**UNITED STATES  
NUCLEAR REGULATORY COMMISSION  
ADVISORY COMMITTEE ON REACTOR SAFEGUARDS  
WASHINGTON, DC 20555 - 0001**

SUBJECT:            CERTIFICATION OF THE MINUTES OF THE ACRS APR1400  
                          SUBCOMMITTEE ON SEPTEMBER 21-22, 2016, ROCKVILLE,  
                          MARYLAND

**SUBJECT:** CERTIFIED MINUTES OF THE ACRS APR1400 SUBCOMMITTEE  
MEETING ON SEPTEMBER 21-22, 2016

ADVISORY COMMITTEE ON REACTOR SAFEGUARDS  
MINUTES OF THE APR1400 SUBCOMMITTEE MEETING ON  
SEPTEMBER 21-22, 2016, ROCKVILLE, MD

Figure 2.0-1 Horizontal Certified Seismic Design Response Spectra

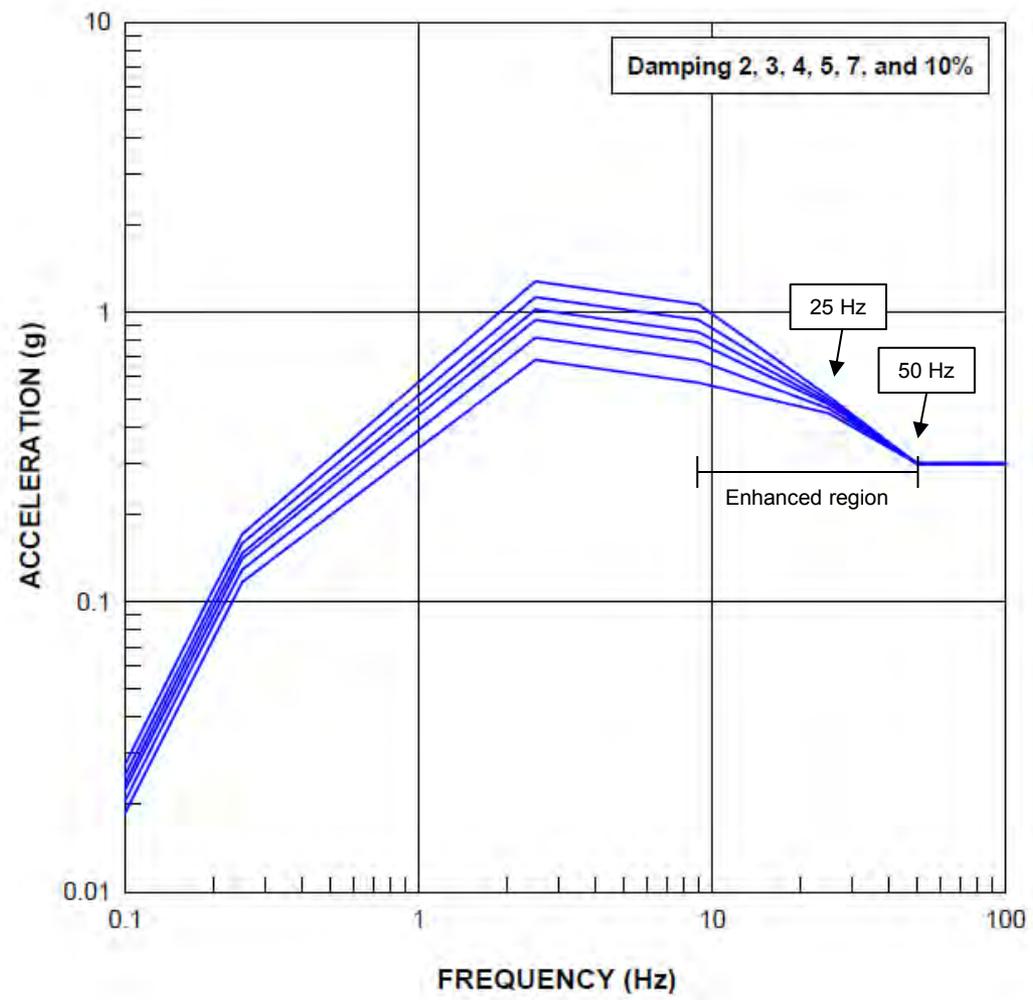
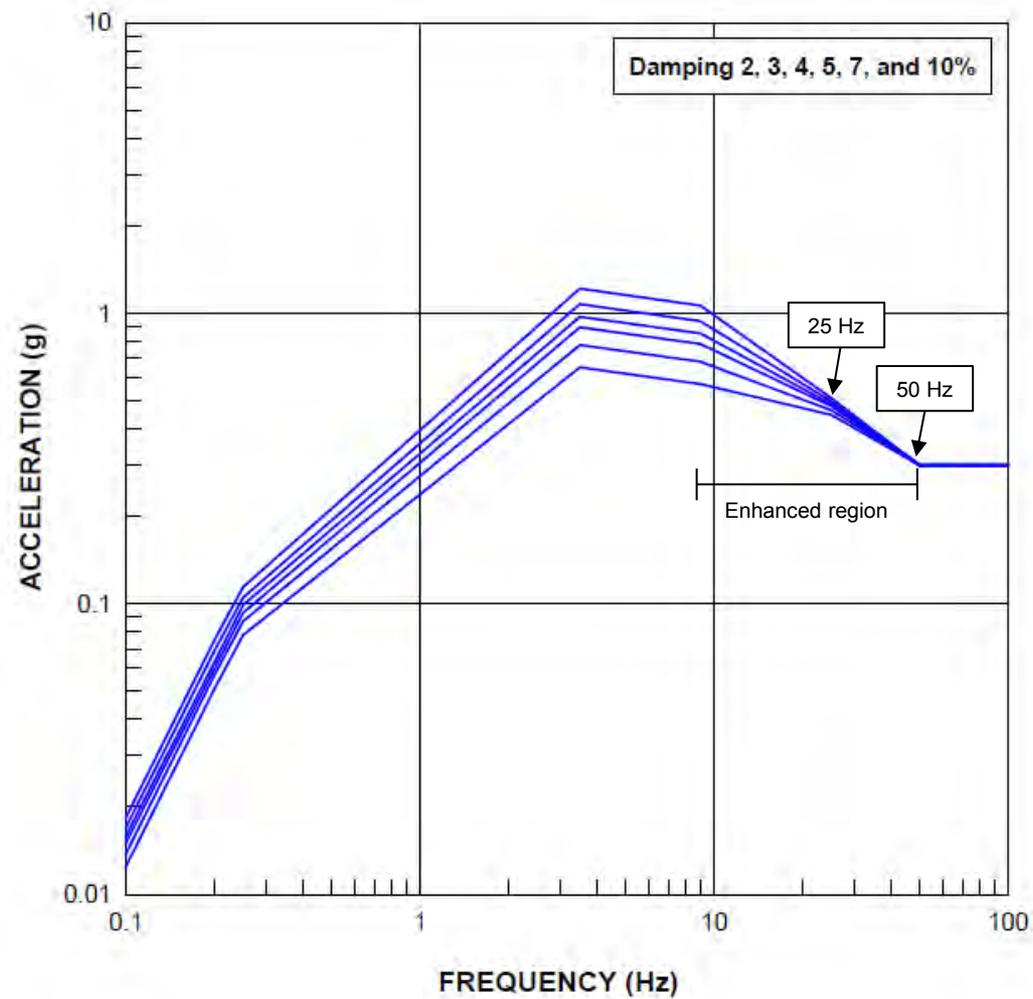
Mr. Koh presented DCD Section 2.5 that describes geology, seismology, and geotechnical engineering. He discussed how various response spectra are developed/used. KHNP to fix DCD Tier 2 Figures 2.0-1 and 2.0-2 (Tier 1 Figure 2.1-1 and 2.1-2) for certified seismic design response spectra by labeling the damping values.	43-46 Slides 14-18

15 CHAIRMAN BALLINGER: With respect to  
16 this Figure 2.0.1 and 2, by the way, in the DCD  
17 nothing is labeled. This figure is clearer but --  
18 and I guess we can guess what damping 2, 3, 4, 5,  
19 7, and 10 percent are, but in the DCD there's no  
20 labels at all that tells you anything. So you  
21 probably ought to think about fixing that.

9 MR. KOH: Damping labels will be added  
10 to here.
